Product Change Notification

Bourns® Model SRP4012 and SRP4020 Series Shielded Power Inductors Change to Core Channel Design

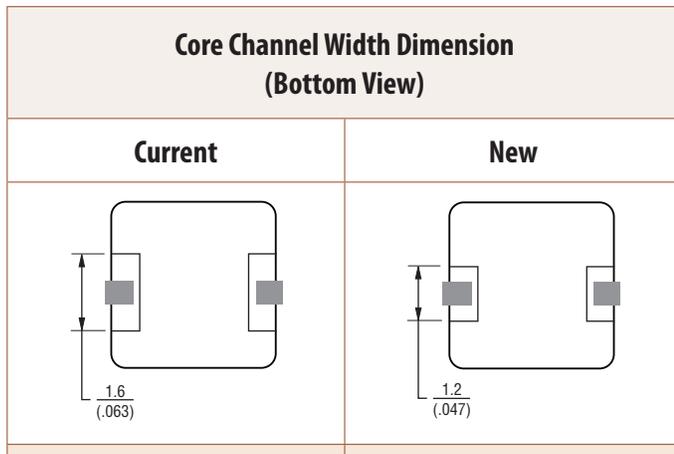
Bourns is changing the core channel design of the [Model SRP4012](#) and [SRP4020 Series](#) Shielded Power Inductors. The terminal positioning will change from 1.6 mm wide to 1.2 mm. Narrowing the core channel will better centrally align the terminal during manufacturing process.

The changes to the inductor core channel design will affect the inductor's form and its quality and reliability should be improved. The inductor's fit and function will remain unchanged. A list of the affected part numbers is shown in Table 1.
